Council Action and Executive Summary

TITLE: AN ORDINANCE APPROVING A CONCEPT PLAN AND FINAL SITE PLAN FOR A PLANNED UNIT DEVELOPMENT (PUD) KNOWN AS DAVE MCTIMSKI INC. THE SUBJECT PROPERTY ENCOMPASSES 15.503 ± ACRES AND IS LOCATED ON THE SOUTHWEST CORNER OF NORTHRISE DRIVE AND ROADRUNNER PARKWAY; PARCEL ID# 02-41024. SUBMITTED BY QUANTUM ENGINEERING CONSULTANTS ON BEHALF OF LORD WILLIAM S & ETAL C/O RANDY MCMILLAN, PROPERTY OWNER (PUD-10-02 & PUD-10-03).

**Planning & Zoning
Commission
Staff Report**

PROJECT NAME: Dave McTimski Inc. PUD (Planned Unit Development)

SHEET NO.: C-5 OF 5 SHEETS

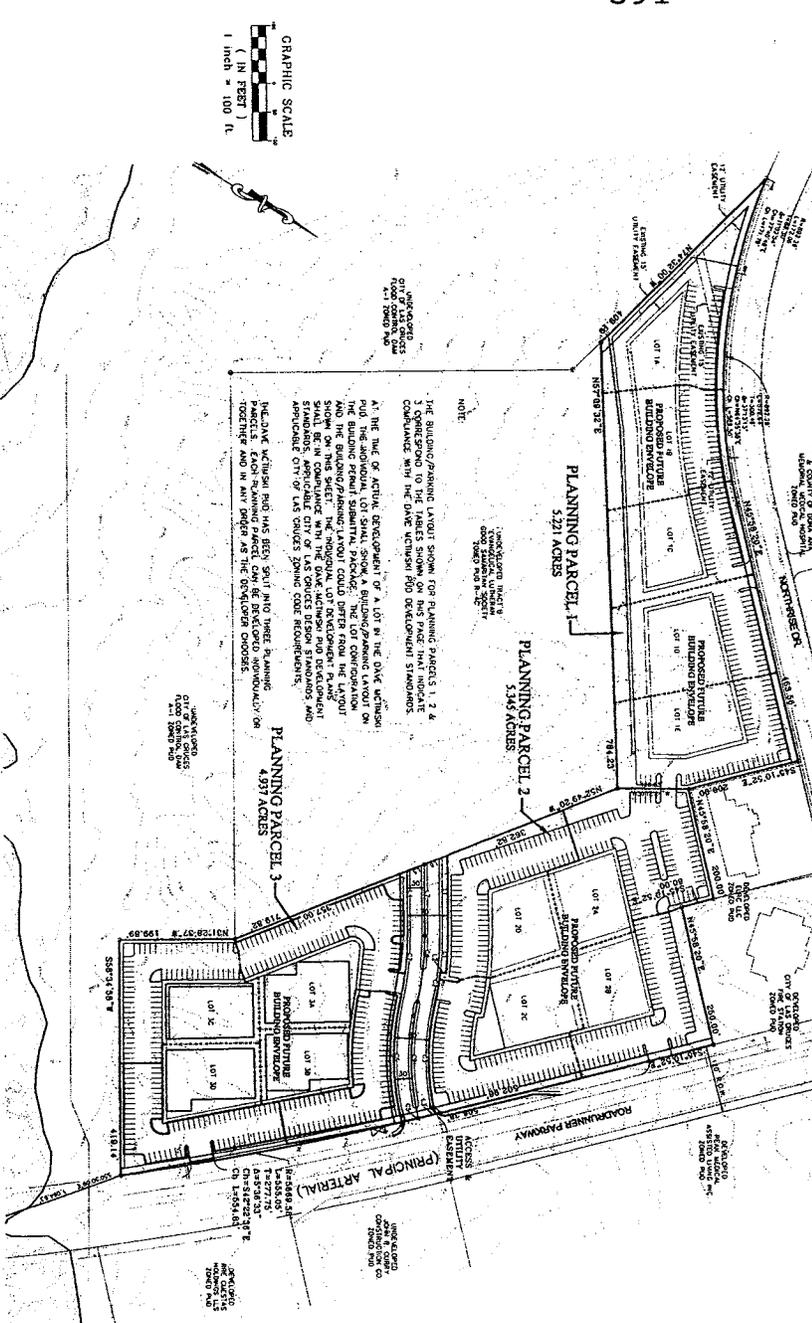
3. On the McTimski Concept Plan, Mixed Use Development - Item 10.7 should be revised. The NDC will require the minimum 20 % site landscaping (or natural) be met on each submittal, not applicable to the entire site(s) en-gross (as stated).

4. On the McTimski Concept Plan, the schematic drawing of parking and pads (Sheet C-5) is reviewed as a concept – not a preliminary of final design. Considerable attention to parking lot landscaping will be required to conform to the guidelines.
